## 1. Modifications with respect to RfP

### 3. Pre-Bid Clarifications

### 3. Drawing of Meter Boxes

#### 1. Drawing of SMC Single Phase Meter Box

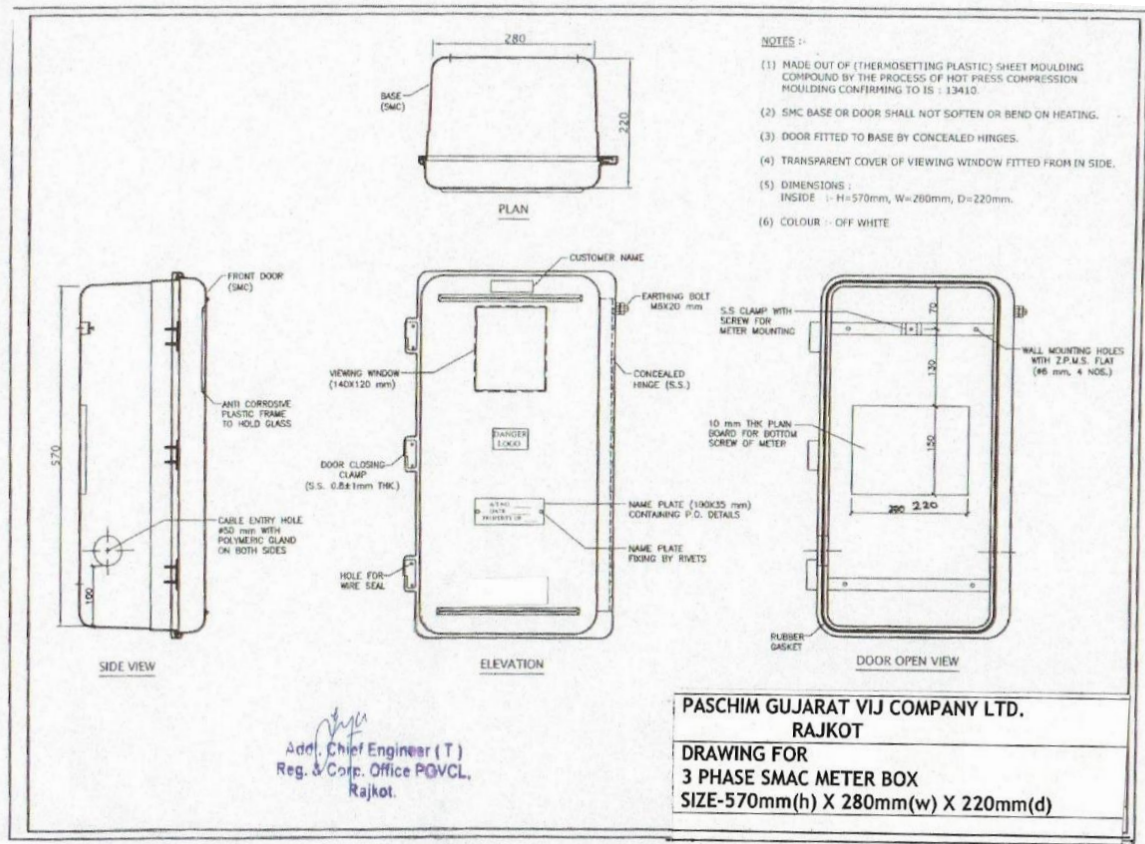
S. No.	Page/ clause no.	Clause as per RFP	Bidder's Query	Clarification to be issued to Bidders
20	Page 279. Appendix A.2	Single phase Whole Current meter SMC box drawing	In appendix only drawing of SMC meter box is attached, which is also very unclear. If SMC box is required then kindly provide technical specification of the SMC meter box with clear drawing.	The dimensions of SMC Boxes for meters is mentioned in Annexure M. The Drawings are attached attached again as a part of Corrigendum. Refer Point 3 of Corrigendum.
21	Page 287. Appendix B.2	3 phase Whole Current meter SMC box drawing	In appendix only drawing of SMC meter box is attached, which is also very unclear. If SMC box is required then kindly provide technical specification of the SMC meter box with clear drawing.	The dimensions of SMC Boxes for meters is mentioned in Annexure M. The Drawings will be attached again as a part of Corrigendum. Refer Point 3 of Corrigendum.

### 4. Tamper Condition No 38 for APPENDIX- A.1 TAMPER CONDITIONS FOR SINGLE PHASE METER, Page-276-277

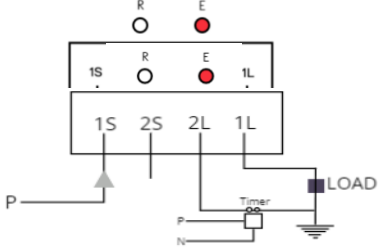
S. No.	Page/ clause no.	Clause as per RFP	Modified Clause
8	APPENDIX- A.1 TAMPER CONDITIONS FOR SINGLE PHASE METER, Page-277		<i>*New Condition Added*</i>  <i>Please Refer Point 4</i>
9	APPENDIX- B.1 TAMPER CONDITIONS FOR THREE PHASE WHOLE CURRENT METER, Page-284		<i>*New Condition Added*</i>  <i>Please Refer Point 5</i>
10	APPENDIX- C.1 TAMPER CONDITIONS FOR THREE PHASE LTCT SMART METERS, Page-289		<i>*New Condition Added*</i>  <i>Please Refer Point 6</i>
11	Section 6 Project Requirement, 1.4 Brief Scope of Work, D, Page-166	D. Consumer indexing on de-novo basis for contiguous electrical locations in the selected AMI Project Area along with its regular updates during contract period as per Clause 4 of this Section;	D. Consumer indexing on de-novo basis for  i. Contiguous electrical locations in the selected AMI Project Area along with its regular updates during contract period as per Clause 4 of this Section. <b>ii. Non-contiguous electrical locations , i.e., Consumer indexing with DTs on de-novo basis along with its regular updates during contract period as per Clause 4 of this Section; and feeder to DT indexing on de-novo basis for all DTs in along with its regular updates during contract period as per Clause 4 of this Section.”</b>  <i>(Reference to Addendum issued by REC dated 28.09.2022 vide Letter No: REC/PMD/AMISP/2022-23/270)</i>
